Memo

TO: Conservation Commission Members
FROM: Kate Homet, Environmental Planner; Peter Britz, Director of Planning & Sustainability
DATE: February 7, 2025
SUBJ: February 12, 2025 Conservation Commission Meeting

**185- 187 Wentworth House Road
Sea Level LLC
Assessor Map 201 Lot 14**

**56 Ridges Court
Rainboth Revocable Trust
Assessor Map 207 Lot 63**

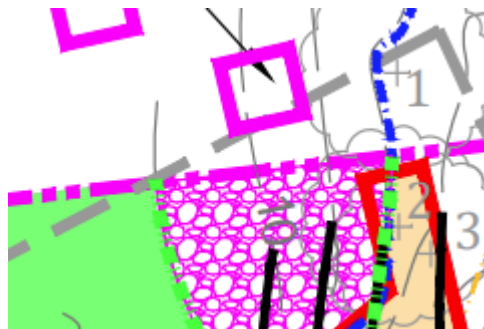
1. The applicant should consider extending the protective coir log to completely enclose the proposed mixed stone/riprap area (see area below). Additionally, the applicant should consider extending erosion control to encapsulate all edges of the newly restored upland site (green area).
